SERVICE BULLETIN

6661Tx-xxx-C, 6661Ux-xxx-C, 6662Ax-xxx-C, 6662Bx-xxx-C

Diaphragm Pumps Seat Change

RELEASED: 06-30-09
REVISED: 1-10-12
Rev 01
BULLETIN: #2-09

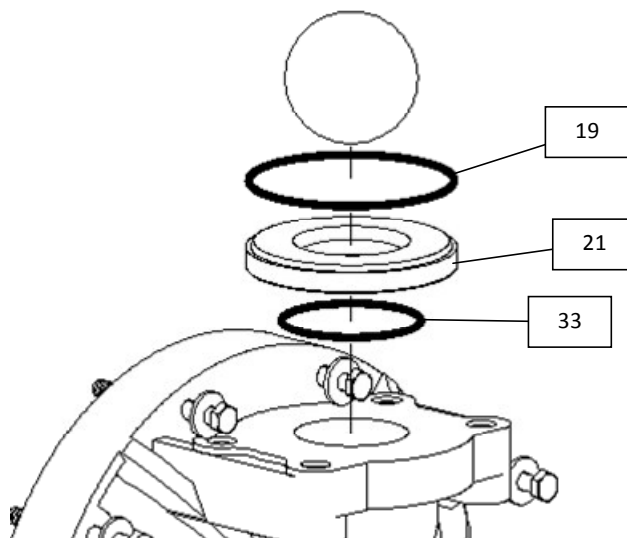
Item 21 Seat Design has change and Item 19 O-ring has been changed to a larger cross section. No changes to item 33 O-ring

This change effective on serial numbers after G0069xxx for polypropylene seats and H0019xxx for PVDF and Stainless Steel Seats.

637165-xx Service Kit will contain both item 19 O-rings.
